UNITED STATES
NUCLEAR REGULATORY COMMISSION
WASHINGTON, D.C. 20555-0001

SUBJECT: COLUMBIA GENERATING STATION - STAFF ASSESSMENT OF INFORMATION PROVIDED UNDER TITLE 10 OF THE *CODE OF FEDERAL REGULATIONS* PART 50, SECTION 50.54(f), SEISMIC HAZARD REEVALUATIONS FOR RECOMMENDATION 2.1 OF THE NEAR-TERM TASK FORCE REVIEW OF INSIGHTS FROM THE FUKUSHIMA DAI-ICHI ACCIDENT (CAC NO. MF5274)

STAFF ASSESSMENT BY THE OFFICE OF NUCLEAR REACTOR REGULATION

COLUMBIA GENERATING STATION

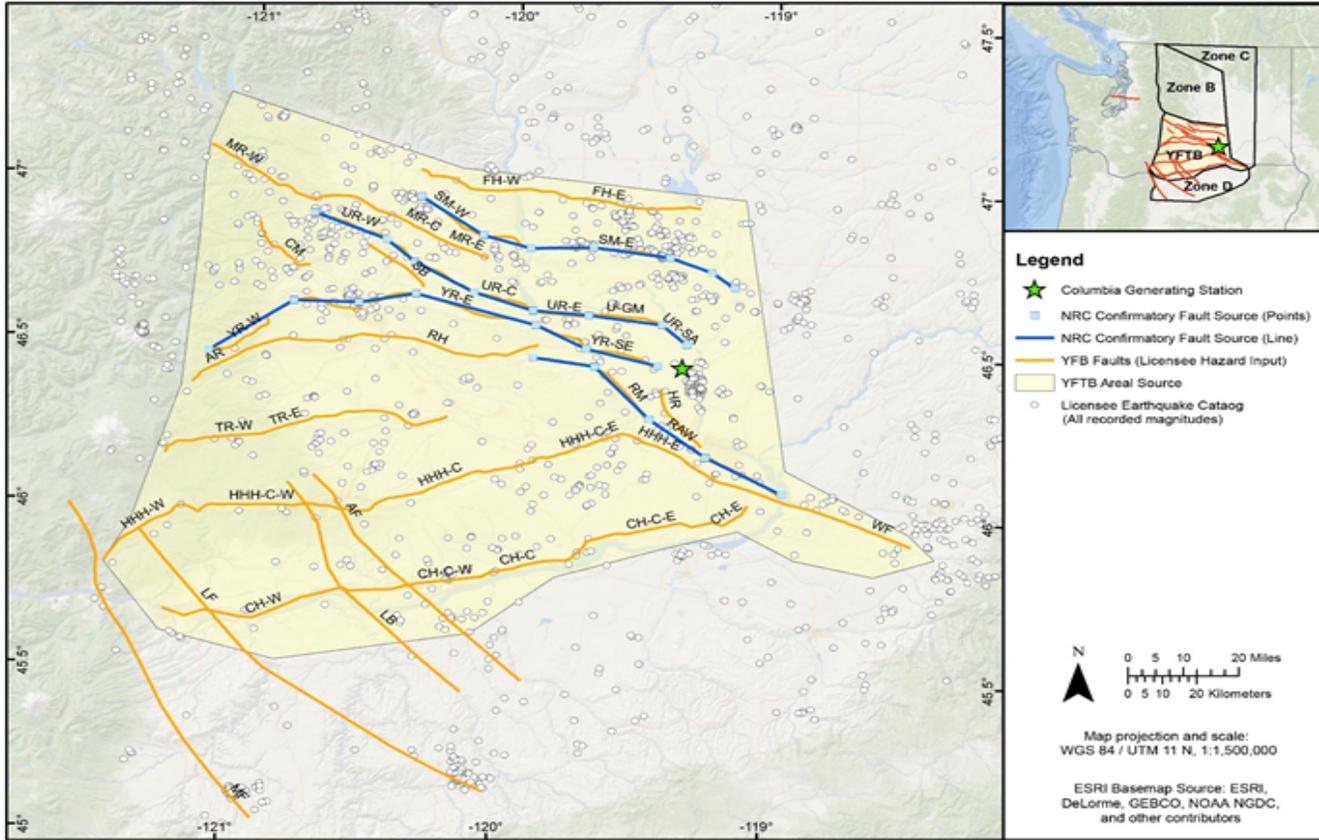
The TI Team identified twenty Quaternary fault sources as having the potential to contribute to the seismic hazard at the Hanford site. Nineteen of these are part of the YFTB faults (Figure 3.1-3 of this staff assessment). The 20th is the Seattle fault, which is located more than 200 km west of the Hanford site in the Puget Lowlands. It is a well-characterized Quaternary fault and is assessed as having the highest slip rate of all the faults in the Puget Lowlands (JBA et al., 2012). Sensitivity analyses conducted by the TI Team showed that the Seattle fault does not contribute significantly to the hazard because it is so distant from the site. The TI Team included the Seattle fault in their analysis, using the characterization from JBA et al. (2012), to document the limited contribution these Puget Lowland faults make to the hazard and to justify their decision to exclude the other faults from the Puget Lowlands from the Hanford PSHA.

The TI Team characterized 19 fault sources associated with the YFTB as well as the Seattle fault in the SSC model (see Figure 3.1-3 of this staff assessment). For each of the individual fault sources, the TI Team modeled the faults as a series of straight-line segments, allowing future earthquake ruptures to potentially occur on one or more of the segments. For the YFTB faults, the TI Team determined that the Rattlesnake Mountain, Umtanum Ridge, Horse Heaven Hill, and Yakima Ridge faults are the main contributors to the total hazard for 10 Hz at an annual frequency of exceedance level of 10^{-4} . The TI Team also included the Seattle fault in the SSC model; however, due to its low slip rate (about 1 mm/yr) and large distance from the Hanford site (200 km), the hazard contribution from this fault is small relative to other faults in the YFTB.

Figure 3.2-1. (a) Nine GMPEs for 1 (blue) and 10 (black) Hz spectral accelerations as a function of source-to-site rupture distance for an **M6** earthquake. (b) The same nine GMPEs as a function of magnitude for a rupture distance of 20 km. Dashed red line is the CY14 backbone GMPE.

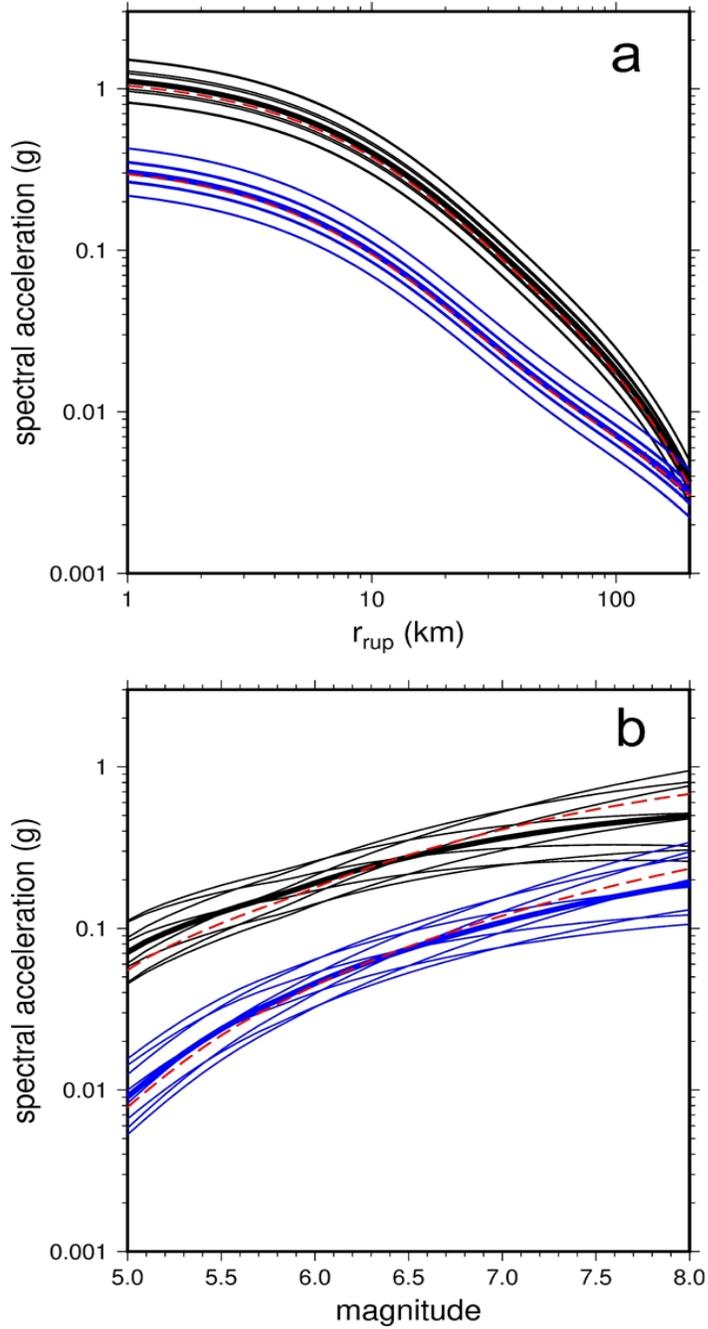
To evaluate the range of alternative magnitude and distance scaling as well as the distribution of median spectral accelerations predicted by the nine GMPEs, the NRC staff examined the behavior of the GMPEs for multiple earthquake magnitude and source-to-site distance combinations. Figure 3.2-1a of this staff assessment shows the nine GMPEs for 1 Hz (blue) and 10 Hz (black) spectral acceleration as a function of source-to-site rupture distance for an **M6** earthquake and Figure 3.2-1b shows the nine GMPEs as a function of magnitude for a rupture distance of 20 km. Figures 3.2-1a and b also show the CY14 backbone GMPE as a dashed red line. The staff also compared the nine GMPEs with the other three NGA-West 2 GMPEs used by the TI Team and notes that the nine GMPEs span a broader range of ground motions than the four input NGA-West2 GMPEs.

As demonstrated in Figure 3.2-1b, the staff notes that the nine GMPEs capture a range of alternative magnitude scaling models (i.e., crossing GMPEs) but, as shown in Figure 3.2-1a, only the distance scaling of the backbone CY14 GMPE. The NRC staff's evaluation of the backbone adjustment model found that the TI Team did develop alternative distance scaling but only for sites located on the hanging wall side of the fault and for source-to-site distances less

Figure 3.2-3. (a) NRC staff's alternative shear-wave velocity profiles for developing V_S -Kappa factors. (b) Comparison of V_S -Kappa factors when using alternative shear-wave velocity profiles for site amplification, based on NRC staff's confirmatory analyses.

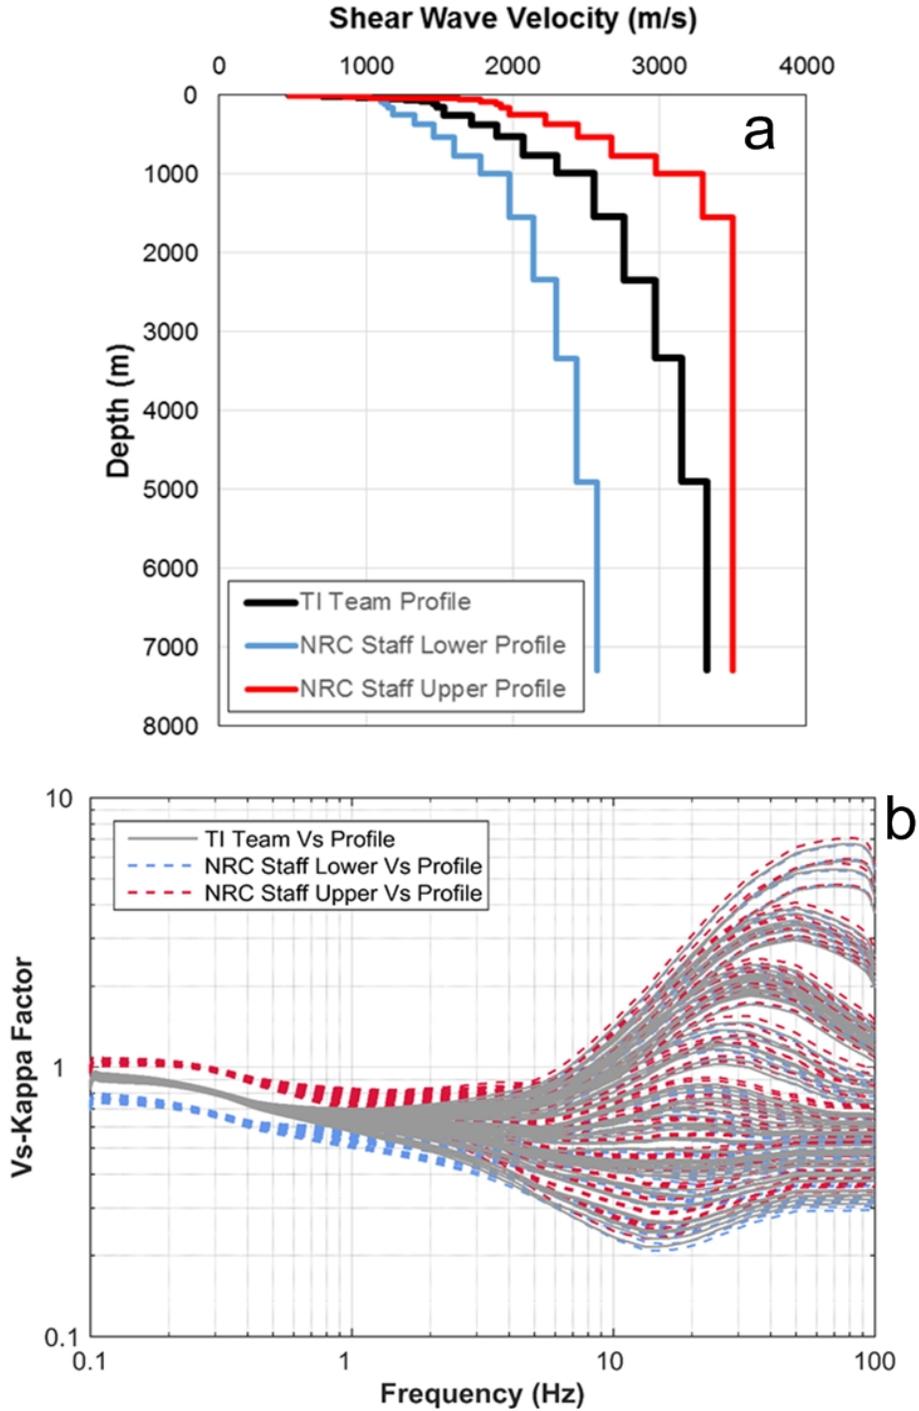
three host V_S profiles, which are shown in Figure 3.2-3a of this staff assessment. As shown in Figure 3.2-3b, the V_S -kappa adjustment factors using three host V_S profiles do not differ substantially from the V_S -kappa adjustment factors developed by the TI Team, which were developed using a single host V_S profile. The NRC staff's confirmatory analysis demonstrates that differences between the host and target kappa values have a much greater impact on the final V_S -kappa adjustment factors than impedance differences between the host and target V_S profiles.

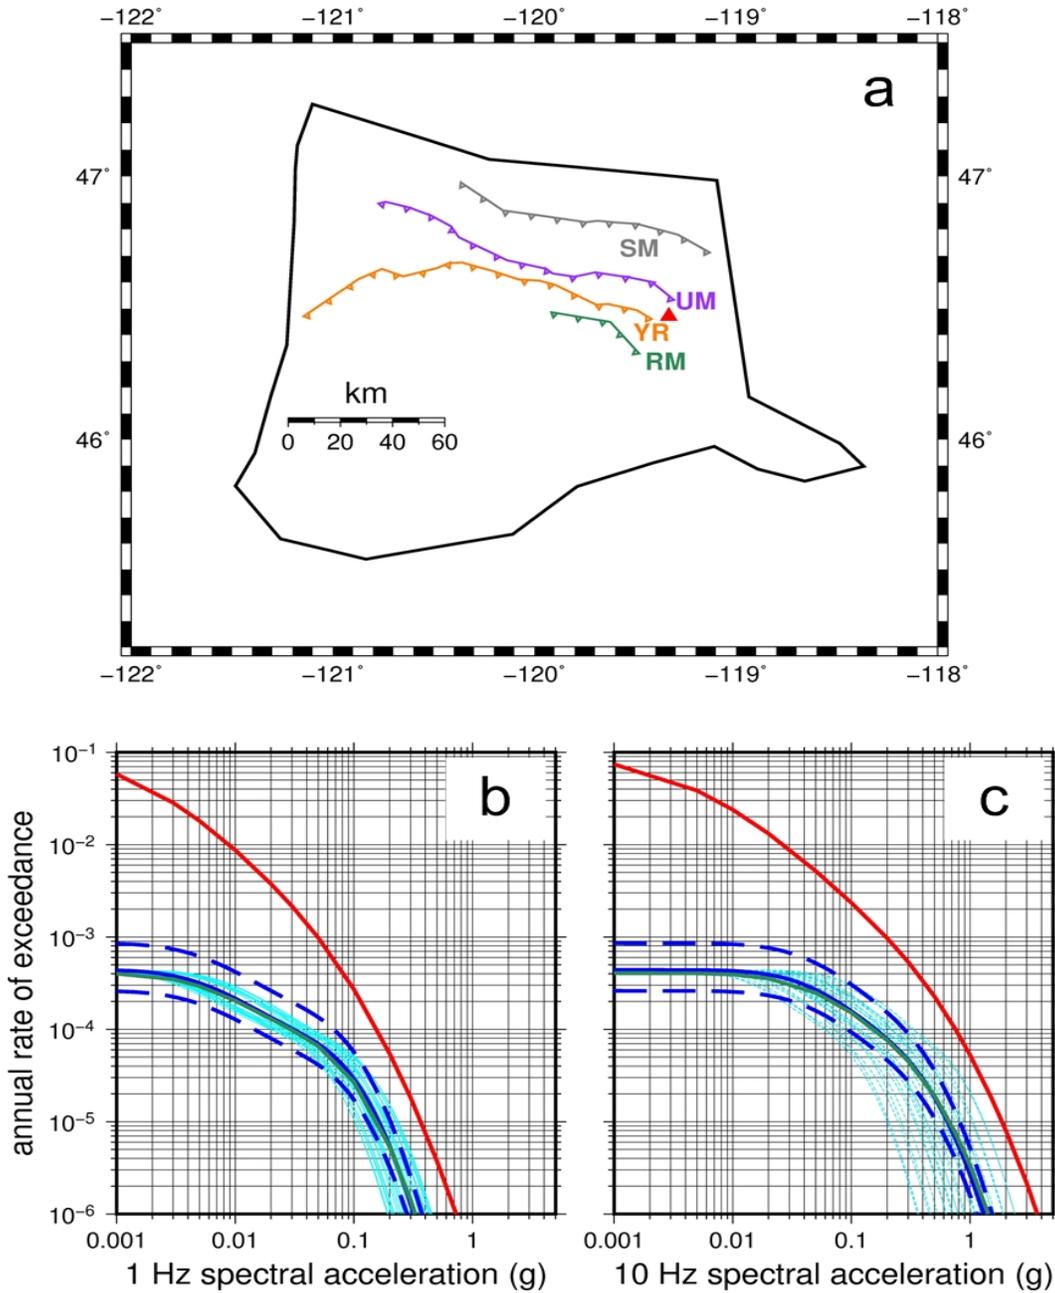
The YFTB fault sources selected by the staff for its confirmatory evaluation are the Rattlesnake Mountain, Yakima Ridge, Umtanum Ridge, and Saddle Mountain faults (Figure 3.3-1a of this staff assessment). For each of the fault sources, the staff evaluated a plausible range of slip rates. Figures 3.3-1(b-c) of this staff assessment show the staff's 1 Hz and 10 Hz hazard curves for the Rattlesnake Mountain fault. For its confirmatory evaluation, the staff used 27 of the 189 crustal earthquake GMPEs, each of which are shown in Figure 3.3-1(b-c). Also shown in Figures 3.3-1(b-c) are hazard curves resulting from using the 5th and 95th percentile slip rates for the Rattlesnake Mountain fault. As shown in Figures 3.3-1(b-c), the staff's confirmatory results closely match the licensee's results for both the 1 Hz and 10 Hz mean hazard curves. Using similar methods, the staff was able to confirm the reasonableness of the licensee's 1 Hz and 10 Hz hazard curves for the Yakima Ridge, Umtanum, and Saddle Mountain faults. The areal source selected by the staff for its confirmatory evaluation is the YFTB source zone, which as the host areal source zone contributes significantly to both the 1 Hz and 10 Hz total mean hazard for the CGS site. Similar to the TI Team's approach, the NRC staff assumed that the majority of the seismicity within the YFTB zone is not associated with YFTB faults. As such, the NRC staff developed a set of virtual faults to generate earthquakes that are not directly associated with known faults within the YFTB. Using the Hanks and Bakun magnitude-area scaling relationships (Hanks and Bakun, 2008), the staff derived the length for each of the virtual faults based on the median MMAX, faulting mechanism, dip angle, and seismogenic thickness as used in the logic tree for the YFTB zone. For each of the virtual faults in the YFTB zone, the staff calculated the hazard using a range of earthquake magnitudes from **M5** to the median maximum magnitude earthquake, which is **M6.8**. The staff developed a suite of seismic hazard curves for each of the virtual faults and then averaged the results to obtain mean 1 Hz and 10 Hz hazard curves for the YFTB source zone.

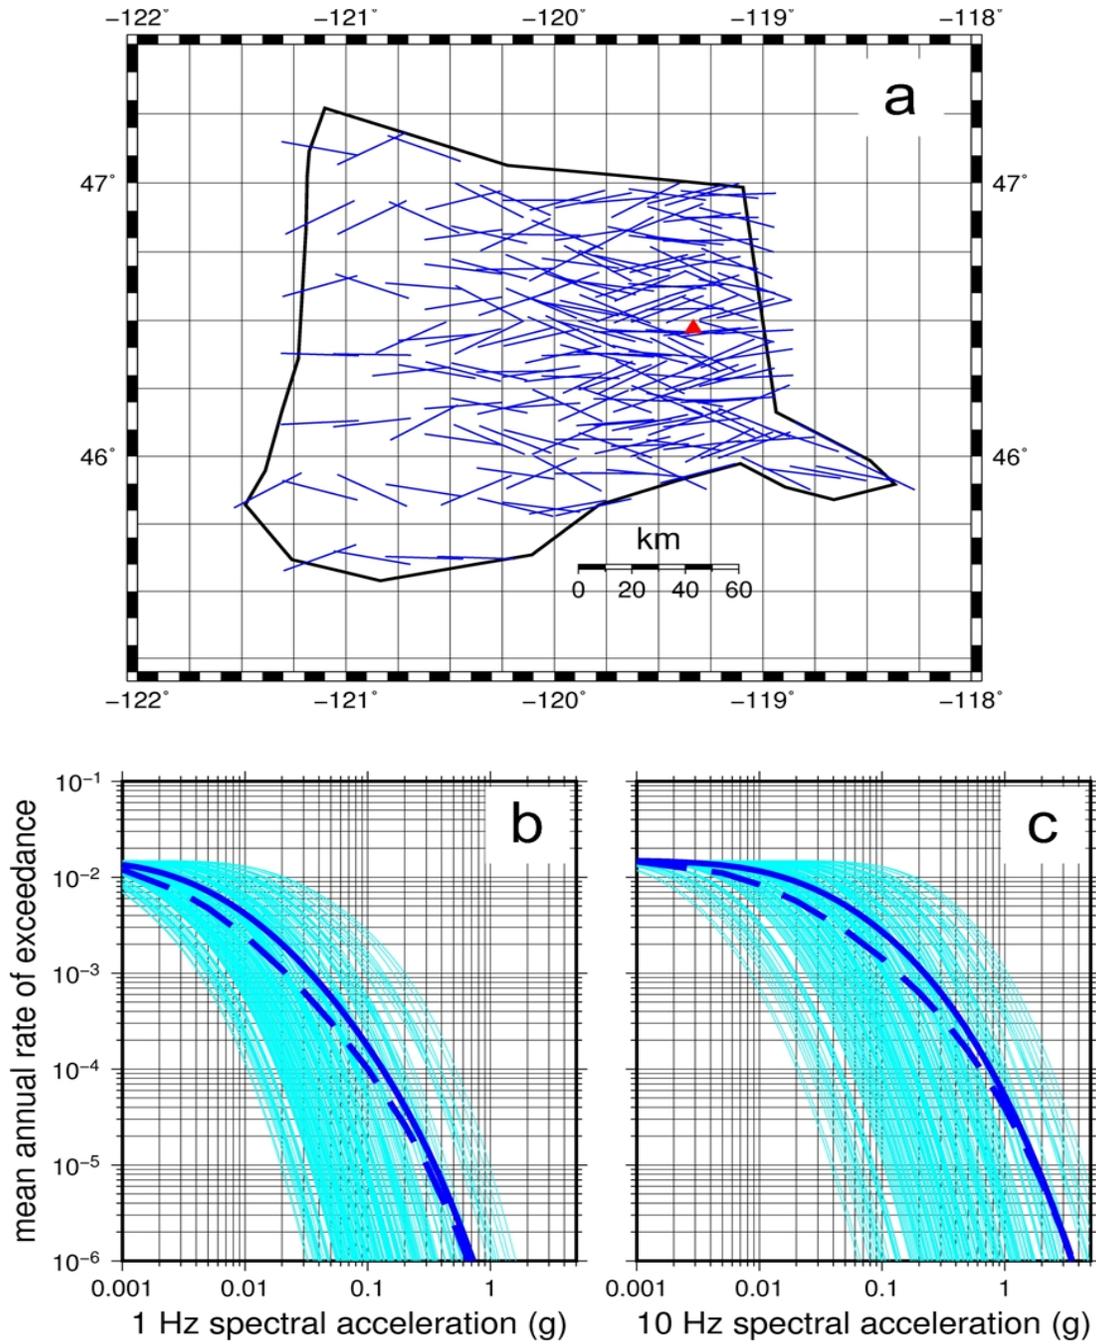
Figure 3.3-2(a) of this staff assessment shows the location of the virtual faults for the YFTB source zone. For its analysis, the staff placed virtual faults more densely around the CGS site and more sparsely at distances beyond 100 km from the site. The staff used this placement of virtual faults to adequately capture the range of significant source-to-site distances. Figure 3.3-2(a) shows the virtual faults for the reverse faulting mechanism, with each fault having a length of about 31 km and a down-dip width of about 20 km. To represent the predominant structural characteristics of the YFTB, the staff selected fault orientations randomly between N60°W and N120°W for the reverse-faulting mechanism. For the strike-slip and normal faulting mechanisms, the staff selected similar predominantly E-W fault orientations. Figures 3.3-2(b-c) of this staff assessment show the 1 Hz and 10 Hz hazard curves for each of the 324 YFTB virtual faults as well as the staff's and licensee's mean hazard curves. As shown in Figure 3.3-2(b-c), the staff's confirmatory results closely match the licensee's results for both the 1 Hz and 10 Hz mean hazard curves.

Figure 3.4-3. Comparison of licensee's and NRC staff's hazard curves at (a) 1 Hz spectral acceleration and (b) 100 Hz spectral acceleration.

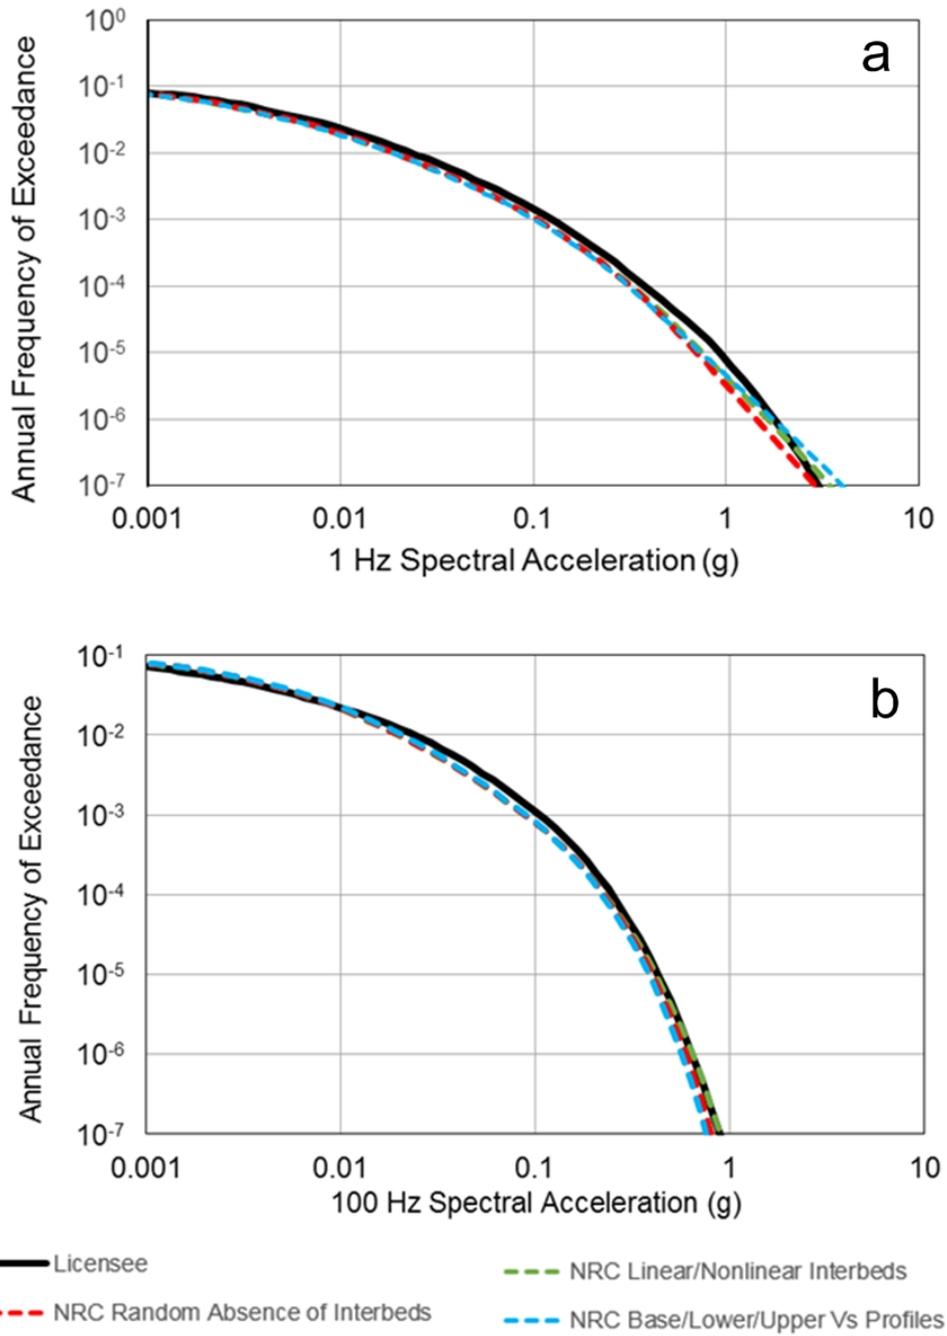
The NRC staff performed a confirmatory site response analyses to assess three different scenarios: (1) the effect of differing assumptions for the epistemic uncertainty and aleatory variability for the site base case V_s profiles; (2) the sensitivity of the site amplification factors to the thickness of the interbed layers within the Saddle Mountain Basalt; and (3) the licensee's use of the Darendeli shear modulus degradation and damping curves (Darendeli, 2001) for the sedimentary interbeds. To assess Scenario 1, the NRC staff developed three profiles for the upper 160 m using a log standard deviation of 0.25 to account for epistemic uncertainty in the subsurface properties, instead of using only a single base case V_s profile. Figure 3.4-1 of this staff assessment shows the NRC staff's middle, upper, and lower base case profiles along with the recorded V_s data in the upper 160 m. To evaluate the sensitivity of the site amplification factors to the thickness of the interbed layers within the Saddle Mountain Basalt (i.e., Scenario 2), the NRC staff performed its analysis by randomly removing a few of the interbed layers in the 60 randomized site profiles. To assess Scenario 3, the NRC staff also performed its site response analysis using either the Darendeli (2001) curves or by assuming a linear response for the interbeds. Figure 3.4-2 shows the staff's confirmatory analyses results for the three scenarios for both 1 Hz (a) and 100 Hz (b) median amplification factors and 1 Hz (c) and 100 Hz (d) log standard deviations. As shown in Figure 3.4-2, the impact of using multiple base case profiles, randomly varying the thickness of the interbeds, and assuming a linear response for the interbed layers, does not result in amplification factors that differ significantly from those developed by the licensee. Similarly, Figure 3.4-3 of this staff assessment shows that the 1 Hz
